# CRISIS ZONE DX - MODIFICATION

# CRISIS ZONE

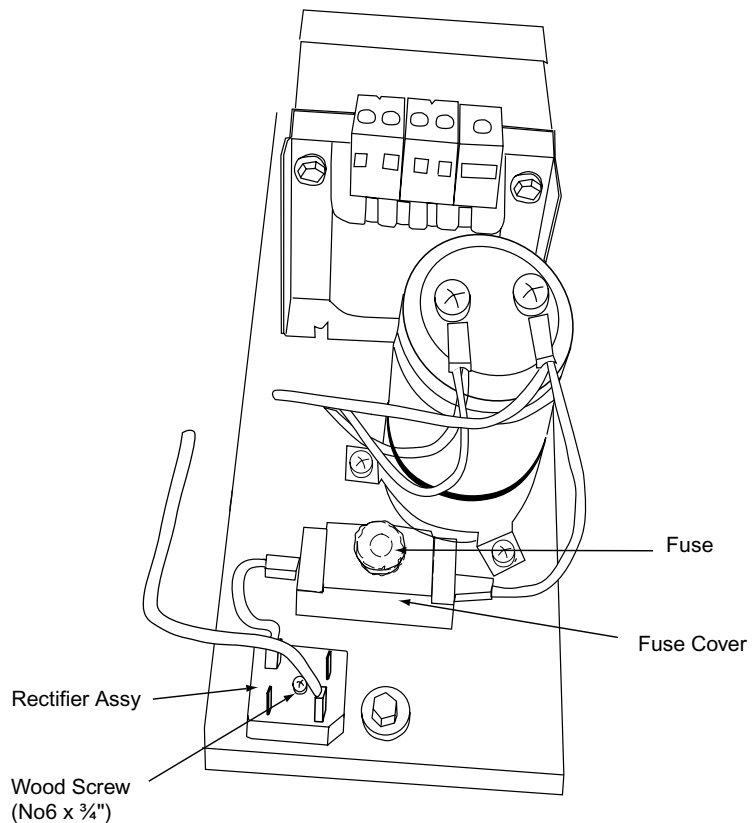
- 2 Fit the new bridge rectifier as shown below using 1 off wood screws No6 x  $\frac{3}{4}$ ".

- 4 Disconnect the grey wire, going to the gun, from the fuse holder.

- 5 Connect the wire, with the flat blade, from the rectifier to the grey wire previously removed from the fuse holder.

- 5 Connect the other wire from the rectifier to the fuse holder.

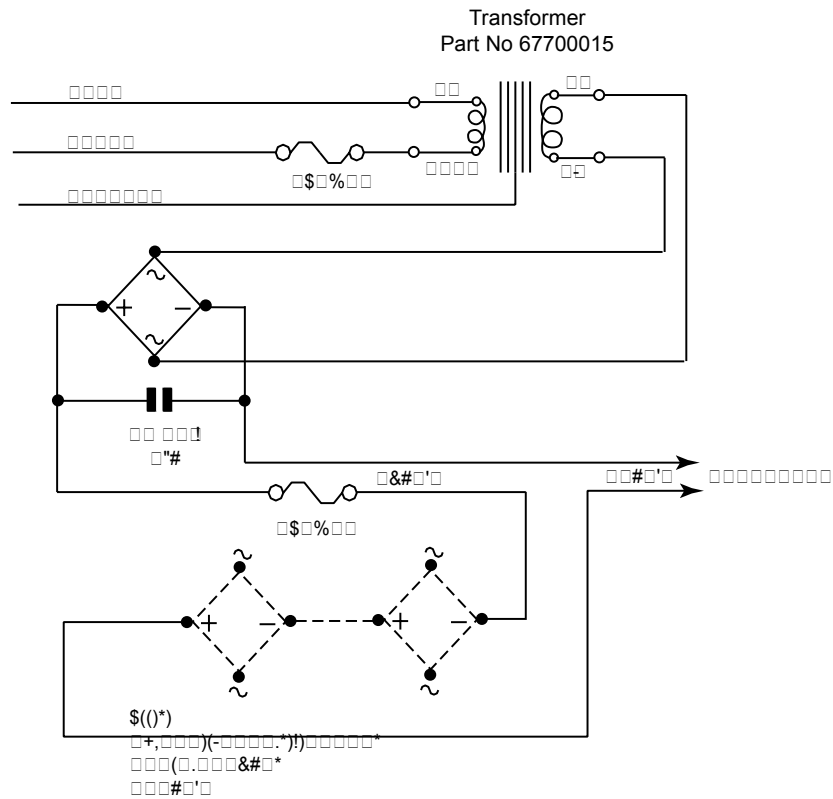
To extend the life of the Gun Motor, it has become necessary to reduce the voltage to the motor from 24v DC (as shown on the schematic), to 22v DC.

This has been accomplished by the addition of 1 or 2 bridge rectifiers placed in the circuit between the 24v DC 3A Fuse and the Gun PCB.

Bridge Rectifier  
Part No. 71000040
